Canon SERVICE MANUAL REPORT

Serial No. AC10-016

REGARDING CHANGED IN CHECKING METHODS FOR SHUTTER RELEASES OF CANON FX AND PELLIX

Pertaining to Light Leakage of Canon FX, FP

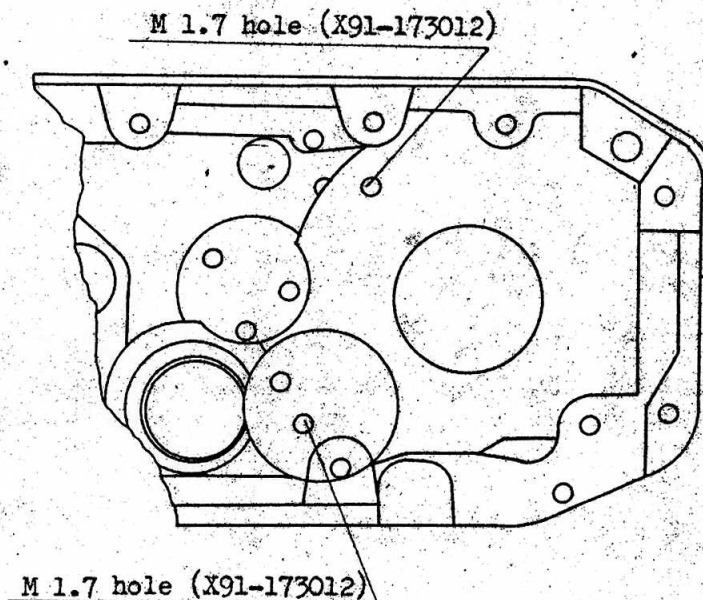
Body (19-9727) of Canon Pellix is diverted to body of Canon FX, FP at present time, however, as the body of Pellix has two more holes compared with the body of FX, FP, refer to the following diagram, if it is assembled without being covered a lid on the holes, there is a danger light might leak.

So if FX, FP which is assembled with this specific body returns to you for repair, no matter what light leaks or not, fill up screw X91-173012 to the holes mentioned above.

Altered Shutter Speed Dial 13-8155 of Canon FX, and FTQL

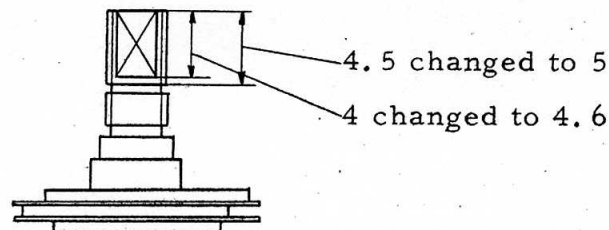
Oval hole position for Shutter Speed Dial 13-8155 of FX, FTQL is made altered to the same position Pellix as follows.

1 Shutter Speed Dial 13-8155

2 Shutter Speed Cam 19-9580

As for FX, if a new Shutter Speed Dial is fixed to the former Shutter Speed Cam, small end play may come out. In this case, cut down about 0.3mm at the bottom of Shutter Speed Dial, then fix it.

There is no question in FTQL, but as to FX, in case of fixing the former Shutter Speed Dial to a new Shutter Speed Cam, both Shutter Speed Dial and Shutter Speed Selector Base are not classified, therefore, take heed when the Shutter Speed Dial is replaced.

REGARDING CHANGE IN ACCESSORY SHOE PARTS OF CANON PX (1-20301) AND CANON PELLIA (1-20311)

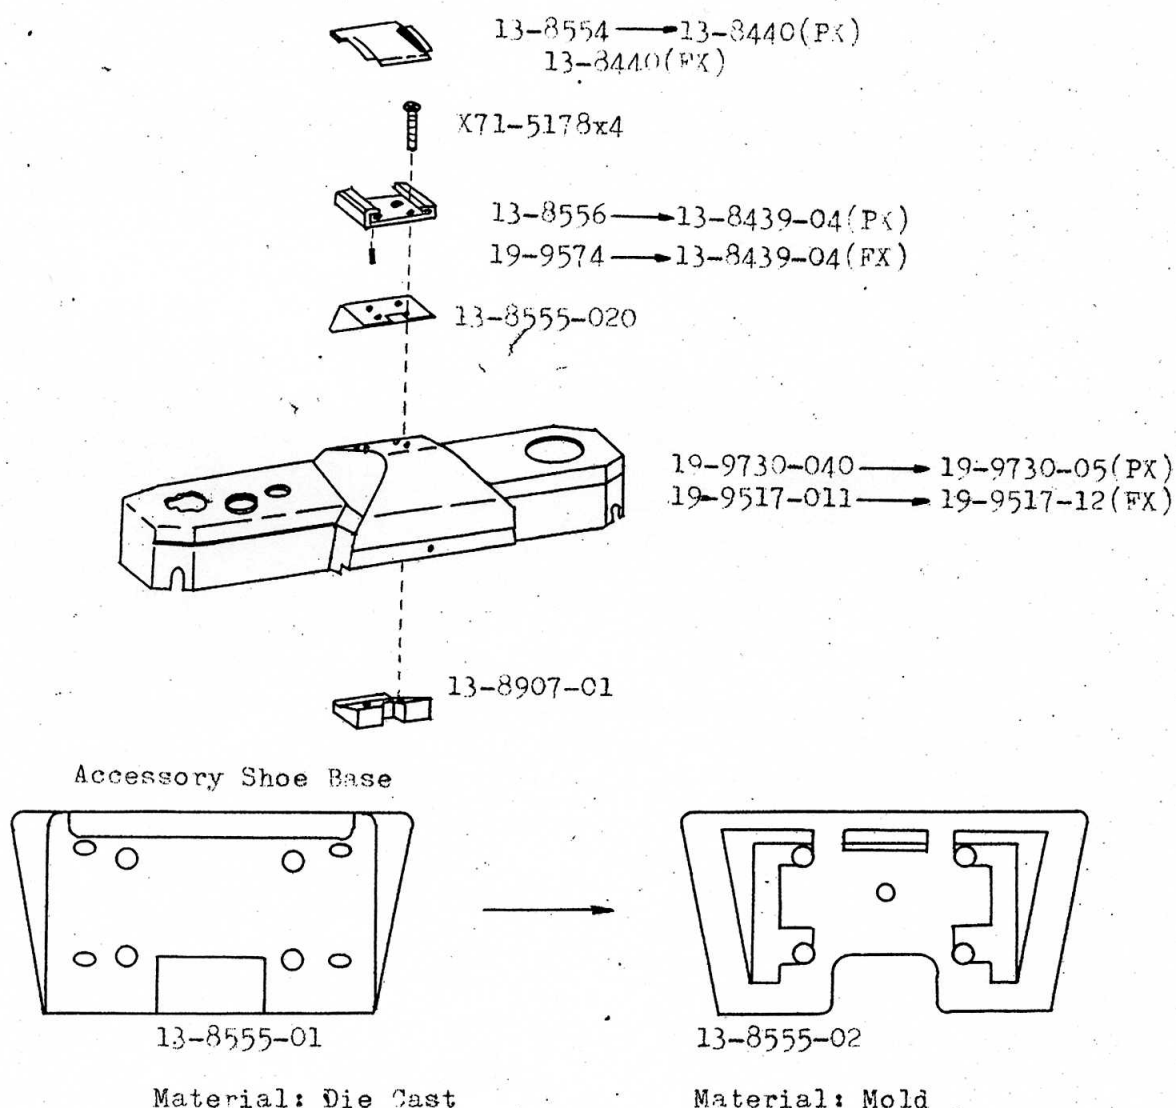
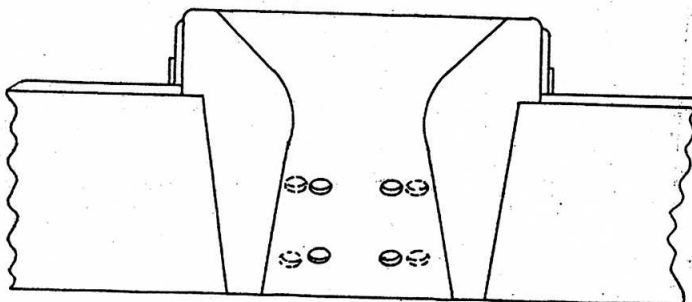
The material for the accessory shoe base (13-8555) has been changed to mold for the purpose of reducing man-hours and production costs.

Furthermore, the screw has been changed to a plus screw (X71-5178) and the accessory shoe tightening plate (13-8907) has been added.

Position of screw hole has been changed.
Dotted line indicates old hole position.

19-9730-040 —→ 19-9730-05 (Pellix)
19-9517-11 —→ 19-9517-12 (FX)

Parts are not interchangeable.

Both the new and old parts are stored by the Service Department. Therefore, when requesting parts, be sure to indicate the parts number.

Body Case (B.P.)
19-9741

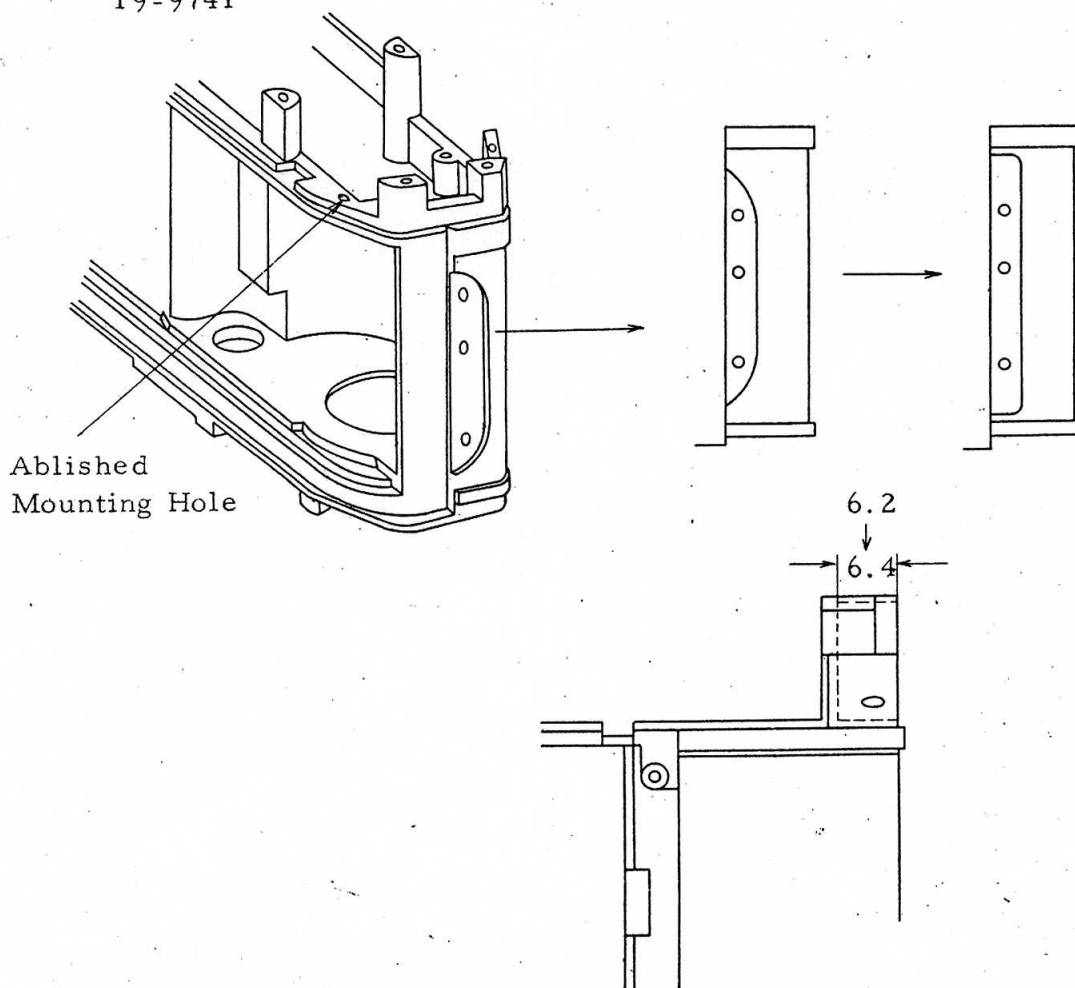
The part of Body Case (B.P.) 19-9741 where hinge is fixed, the part number has been previously altered from 19-9516, is made all common to FTQL and PXQL. The mounting hole of Screw X91-142379 for Reset Lever is abolished. The depth 6.2mm of the Mercury Battery Box is also altered to 6.4mm as well as FTQL and PXQL.

The number 13-8372 Battery Cover is altered to 13-8372-05.
The material vinyl chloride is altered to polypropylene and the
thick 0.2mm is altered to 0.4mm. The number 13-8368
Insulator is altered to 13-8368-03.

The number 13-8326 Hinge is altered to 13-8948.

13-8326 is stopped, then 13-8948 which is common to FTQL and
PXQL is applied instead. Collar 13-8521 and Screw X91-142379
are stopped.

Old Hinge 13-8326 can't be used to the new Body Case.
Old Mercury Cover 13-8372 can't be used to the new Body Case.
Old Insulator 13-8368 can't be used to the new Body Case
19-9741-12, but the new Insulator 13-8368-03 can be used to the
old Body Case 19-9741.

Modified Top Cover and Base Plate, Canon FX

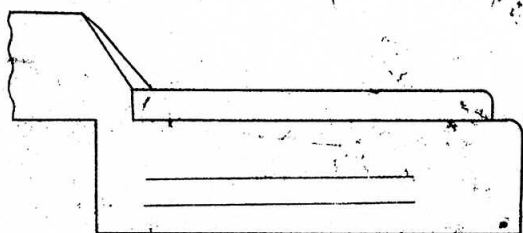
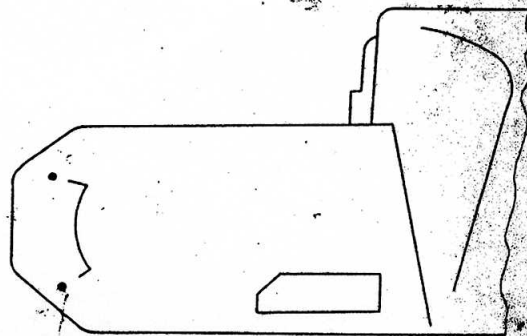
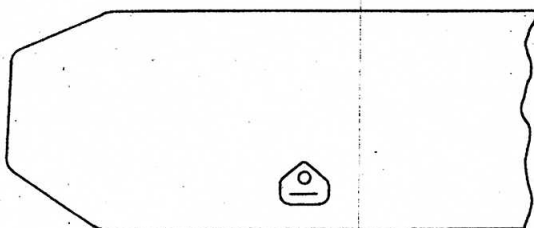
With the alteration of the name, the top cover and the base plate are modified. The carving CANON CAMERA COMPANY, INC. NO. 100001 MADE IN JAPAN on the backside at right hand side of the cover is abolished, but 100001 is put on the surface at left hand side instead and CANON JAPAN is also put on the surface of the base plate.

CANON CAMERA COMPANY, INC.
NO. 100001 MADE IN JAPAN
19-9517

19-9517-14

19-9521-05

The stock of the current parts will be gradually switched over to the modified ones.

Altered Brake Shaft and Body Die Casting, Canon FX

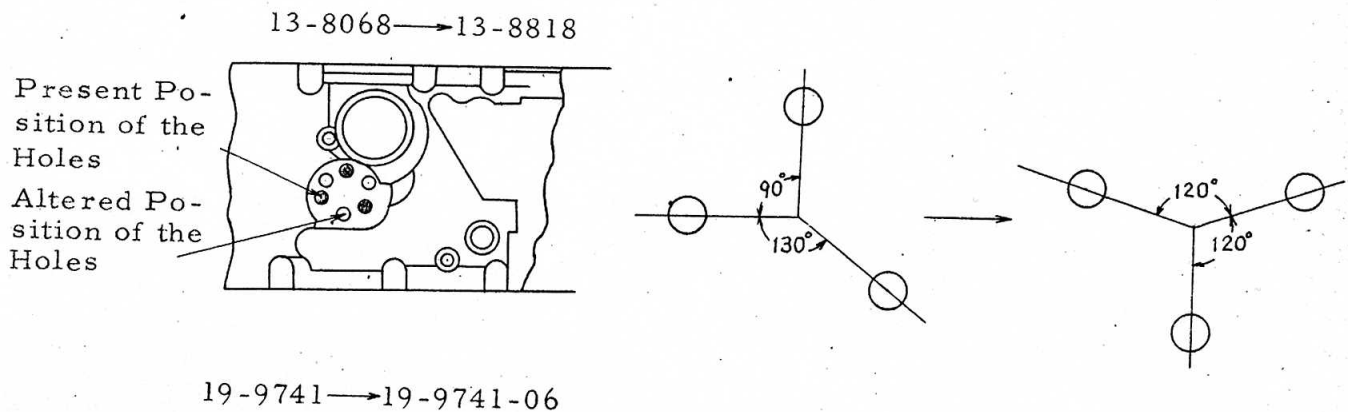
In order to rationalize the processing of perforation in the Body Die Casting 19-9741, which is made common to the processing for FT and PXQL, the position of the mounting holes for Brake Shaft 13-8068 is altered as illustrated below. Consequently, the Brake Shaft is altered to the same one which is used for FT and PXQL.

It is not possible to pair neither the present Brake Shaft 13-8068 to the altered Body Die Casting nor the altered Brake Shaft 13-8818 to the present Body Die Casting. Both present and altered Brake Shafts are stocked for spare.

Rewind clamp Lever 13-8194

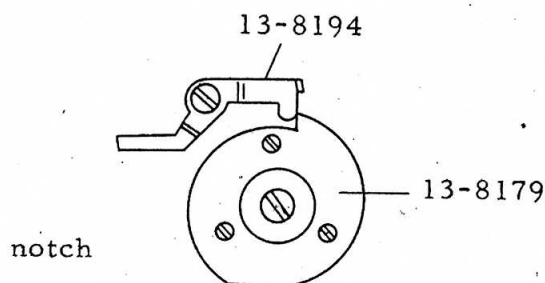
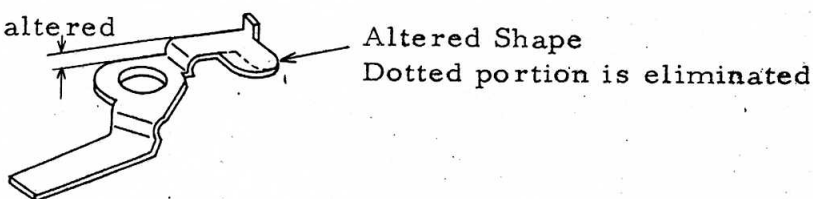
When winded up, Rewind Clamp Lever gets into notch of Cover Plate 13-8179 so that further winding sometimes becomes incompetent.

And also on the way of winding, the Rewind Clamp Lever gets in under disk and jams with gear so that return of Winding Lever (B.P.) becomes inferior. For the prevention, Rewind Clamp Lever, and Cover Plate are altered as illustrated below.

0.4 is altered
to 0.6

The thickness 0.8 is altered to 1.0mm

The respective present and altered parts of 13-8179 and 13-8194 are not interchangeable. If 13-8194 is replaced to the altered one, replace 13-8179 to the altered one without fail. Specify PRESENT or ALTERED parts when ordering.
